Re: West DuPage Recycling and Transfer Station Draft Siting Application Review

On behalf of the City of West Chicago, APTIM Environmental and Infrastructure LLC (Aptim) and Walter Willis have completed a review of the updated Draft of the Siting Application (Application) for the Lakeshore Recycling System, LLC (Applicant) West DuPage Recycling and Transfer Station, prepared by Civil and Environmental Consultants, Inc. (CEC). Upon review of the updated Draft, concerns regarding the applicant content and several siting criteria were identified and are summarized below:

Figure 1

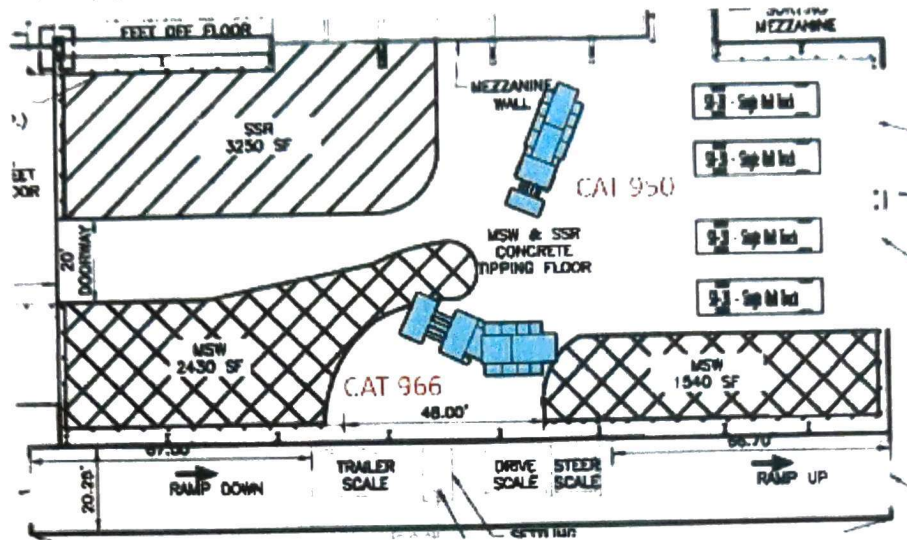
The wheel loaders that are depicted on Figure 2-3 are drawn at a smaller scale than actual size. The loader models being used at Lakeshore's California Ave facility are Caterpillar 980 and 950 for loading and consolidation, respectively. **THE DIMENSIONS OF THE PLANNED LOADERS HAAVE BEEN ADDED TO FIGURE 2-3** The smallest loader recommended by Caterpillar for use in a transfer station that transfers 1,300 tons per day (MSW and SSR) is a 966 model with an 8.5 yd bucket, though an even larger 980 model may be necessary as it apparently is at the California Ave. facility. The 966 and 950 models have lengths of almost 27 feet (without a bucket) and widths of 9.83 and 10.83 feet over tires, respectively. **THE DIMENSIONS ARE SHOWN ON FIGURE 2-3** The loaders shown appear to have length of only approximately 17 feet (without bucket) and a width of approximately 7 feet over tires. Figure 1 imposes more realistic loaders onto the Applicant's Figure 2-3.

As shown, the sizes and locations of the stockpiles create a limited area where the wheel loaders can operate and will prevent a wheel loader from unloading and loading a transfer vehicle as efficiently as presented.

Figure 2

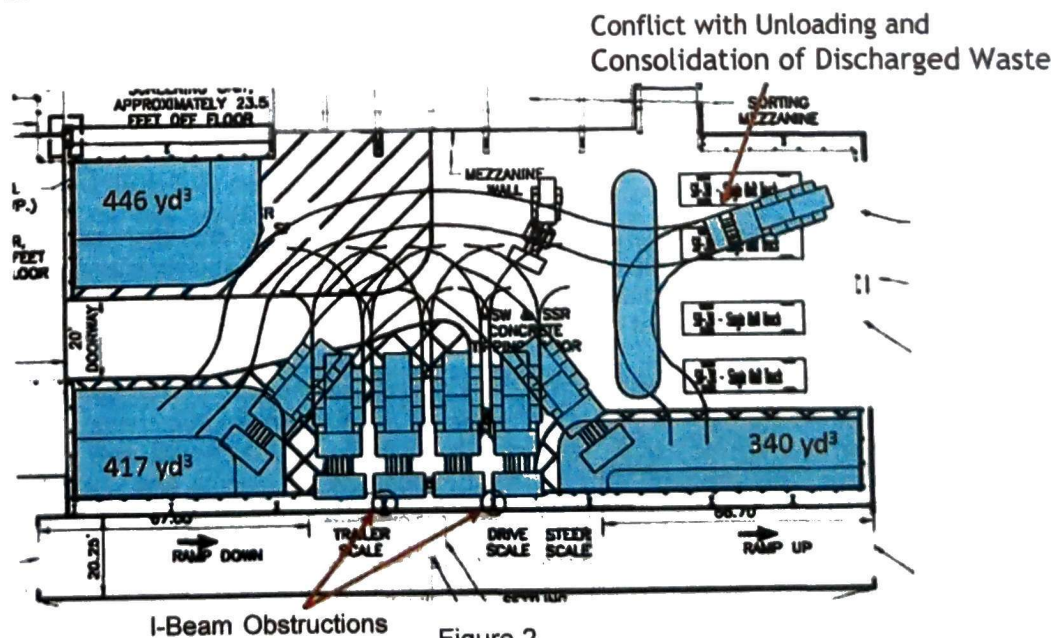
The applicant should provide analyses of the area required on the floor to allow movement of the appropriately sized wheel loaders to accommodate the corresponding turning radius (both for pushing unloaded waste into the pile and loading a transfer vehicle) and how that affects the area available on the floor to store waste. **THE TURNING RADIUS OF THE 980 LOADER IS SHOWN ON FIGURE 2-3 TO DEMONSTRATE THE APPROXIMATELY WORKING ARE FOR THE LOADER.** The current scenario appears not to allow these movements as depicted in Figure 2.

The applicant should provide an analyses of the area required on the floor to allow movement of the

wheel loader or accommodate the corresponding turn radius (both for pushing unloaded waste into the pile and loading a transfer vehicle) and how that will affect the area available on the floor to store waste and the required maximum tons per day. **THE TURN RADIUS OF THE LOADER IS SHOWN ON FIGURE 2-3.**

Figure 2 illustrates more realistic stockpile sizes, each showing a 1:1 working face up to the top of the pushwall (a height of 12 feet) while still allowing relatively free maneuvering of the loaders. It also shows more realistic stockpile sizes. Using the average areas of the pile bases and plateaus on this figure and multiplying by 12 feet, we estimate the total volume of MSW and SSR storage is only 757 cubic yards and 446 cubic yards, respectively.

Figure 2 also illustrates a previously mentioned issue of the need for waste to be consolidated from its discharge area to the southwest stockpile. In addition to the previously described need to reduce the SSR stockpile area, this activity will result in a conflict with unloading and discharge of waste by collection vehicles. It appears that the smaller loader will either be occupying the northern bay door, rendering it unusable, or will have to wait outside between each load. With either scenario, the throughput analyses should be performed in consideration that the northern bay door to be used for unloading only intermittently. If the loader will be waiting outside, it will impede the maneuvering area east of the building.

Drawing C302 and Figure 2-3 both show I beam column supports in front of the loading bay which will prevent (or severely inhibit) the ability to load trailers. These obstructions are identified on Figure 2 of this memorandum. **THE DRAWING AND FIGURES ARE CORRECT. THE COLUMNS SHOWN ARE PRESENT ABOVE THE LOADING PIT FRAMED OPENING. AN ELEVATION VIEW WAS ADDED TO THE DRAWING SET TO SHOW THE BUILDING FRAMING. THE COLUMNS WERE REMOVED FROM THIS LOCATION ON CERTAIN FIGURES TO AVOID CONFUSION.**

To compound this issue is that the primary loader will need a straight run at each section of the trailer as it is filled which obviously cannot occur with the "finger" of waste shown extending into the middle of the floor. In addition to anticipated spillage from the waste and recyclable piles on either side of the doorway which are proposed to extend to the exact edge of the doorway, this finger also prevents equipment access to/from the 20-foot C&D transfer building. It is unclear how or if equipment can get to that door in order to move any non-recyclable C&D material from the C&D transfer building to the transfer building, and vice versa. Additionally, overhead door no. 2 may be blocked by spillage from the smaller MSW pile. This will prevent full usage of the overhead door no. 2 bay and slow the truck acceptance rate. **SEE UPDATED THROUGHPUT EVALUATION AND FIGURE 2-3**

Figure 3

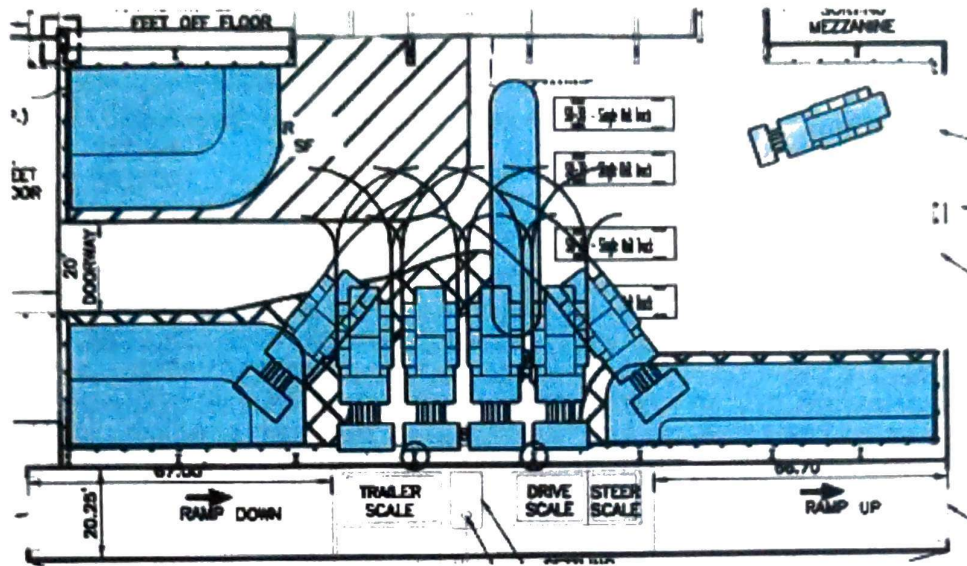
In addition, Figure 3 shows the collection vehicle pulling far enough into the transfer building to unload waste near the stockpile areas, but in doing so, will also require the smaller loader to either be occupying the northern bay door, rendering it unusable, or that it will have to wait outside between each load. This scenario also makes it impossible for loading and unloading to occur simultaneously. All of these issues are anticipated to cause significant delays in the timing of incoming collection vehicles and transfer trailer load-out and, consequently, affect the proposal facility throughput.

In addition to the apparent need for one of the loaders to be blocking one of the bay doors, it is proposed that four vehicles (two per door) can be unloading at the same time. The doors are specified to be 30 feet wide, each. Assuming a width of 10 feet for each truck, **THE MAXIMUM LEGAL VEHICLE WIDTH IN ILLINOIS IS 8.5 FEET**, there will only be approximately 3.3 feet of clearance between the doorjamb and/or adjacent truck in each bay. This is unlikely as it will require near perfect driving from collection vehicles in order to reverse through a shared door without causing an accident. At maximum throughput peak hour, the Applicant plans to dump 28 trucks in the building - 14 trucks through each bay in the busiest hour. This will not be possible if only one bay can be used and if two trucks cannot tip their loads simultaneously in each bay. With only one useable bay and one vehicle in that bay at a time, only 12 vehicles will be able to unload if the applicant's assumption of 5 minutes per dumped load is accurate. Aptim has used a range of unloading times of 4 to 9 minutes (average of 6.5 minutes) which would further reduce the number of vehicles that can dump. **WE ARE USING 5 MINUTES AND BELIEVE THAT THIS IS AN APPROPRIATE AVERAGE TIME.**
